## **DEER RIVER COMMERCIAL PARK SUBDIVISION**

APPLICATION NUMBER 12 DATE June 18, 2009

REQUEST Subdivision

**DETAIL SITE PLAN**

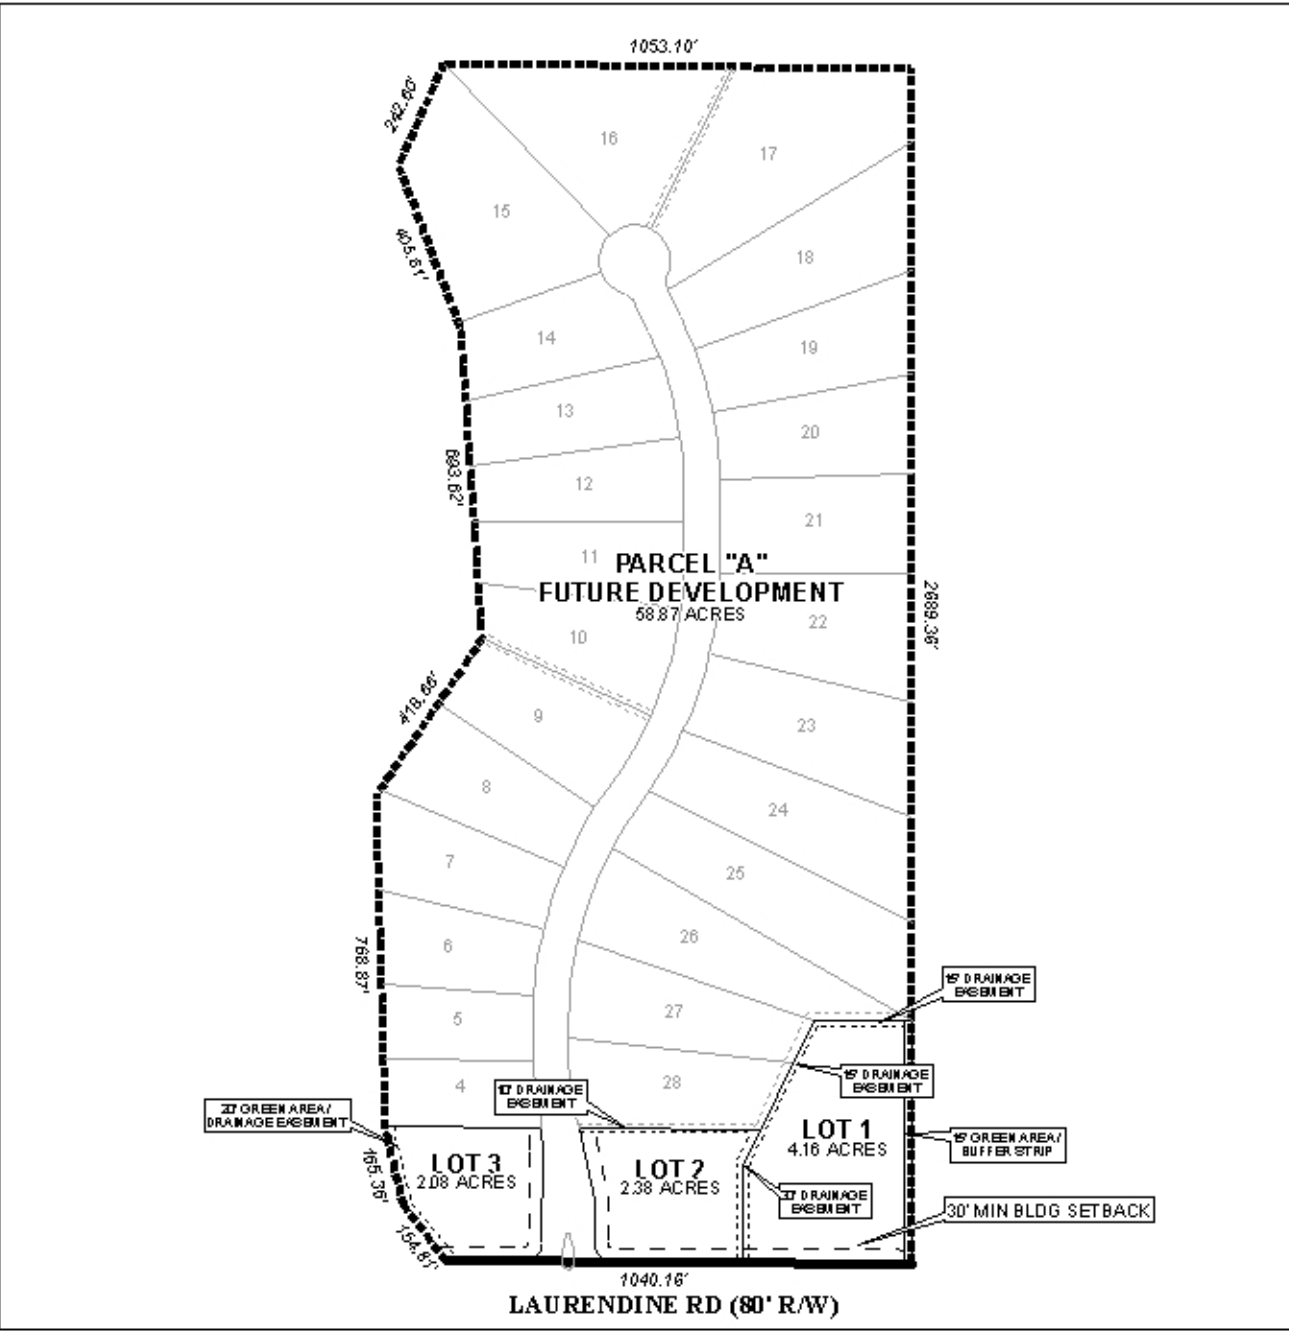
The purpose of this application is to re-subdivide a legal lot of record into four lots. However, the plat illustrates only three lots, with the remainder labeled as “future development,” which the applicant intends to re-subdivide in the future into 25 lots. After consulting with the applicant, the plat will now be revised to label this “future development” parcel as Lot 4, to which it will be referred for the duration of this review.

As proposed, Lots 1, 2, 3 and 4 have approximately 380’ 290’ 170’ and 200’ of frontage along Laurendine Road. As a means of access management, a note should be placed on the final plat stating that Lots 1 and 2 are limited to two curb cuts each, while Lots 3 and 4 are limited to one curb cut each to Laurendine Road, with the sizes, locations, and designs to be approved by County Engineering and in conformance with AASHTO standards.

The applicant has also illustrated a 15’ buffer setback, on Lot 1, from the Eastern property. It should be noted, however, should the lot be developed commercially, this setback alone will not satisfy the buffer requirement of Section V.A.8 of the Subdivision Regulations, which requires a *“buffer consisting of landscaping, a six-foot wooden privacy fence, or when necessary due to negative impacts a combination thereof, is required.”*

- 1) revision of the plat to label the "future development" parcel as Lot 4;
- 2) placement of a note on the final plat stating that Lots 1 and 2 are limited to two curb cuts each, while Lots 3 and 4 are limited to one curb cut each to Laurendine Road, with the sizes, locations, and designs to be approved by County Engineering and in conformance with AASHTO standards;
